Hearing 11 - Transport

Amendment to TRAN-Table 9

Prepared for Far North District Council

Project Number FNDC-J011

Figure 2.3 Abley Report Appendix A TRAN-Table 9 amendments

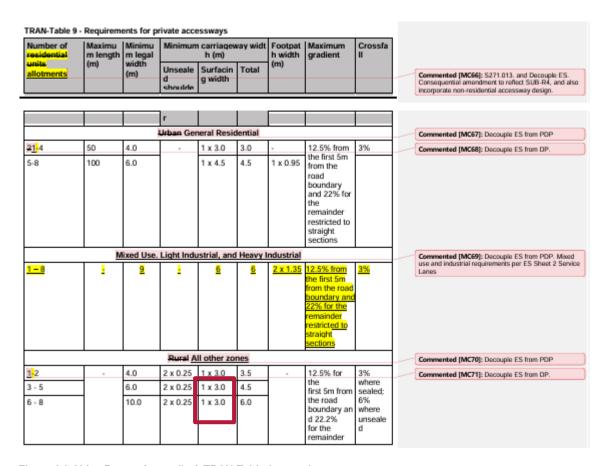
Appendix A to the Abley Report provided Abley's recommended amendments to the Transport Chapter, including to decouple the Council Engineering Standards from the PDP. This included recommended amendments to TRAN-Table 9, which carried over the error from the notified PDP, as shown in Figure 2.3.

We recommend that TRAN-Table 9 is amended as shown in red strikethrough and red underline in the table below.
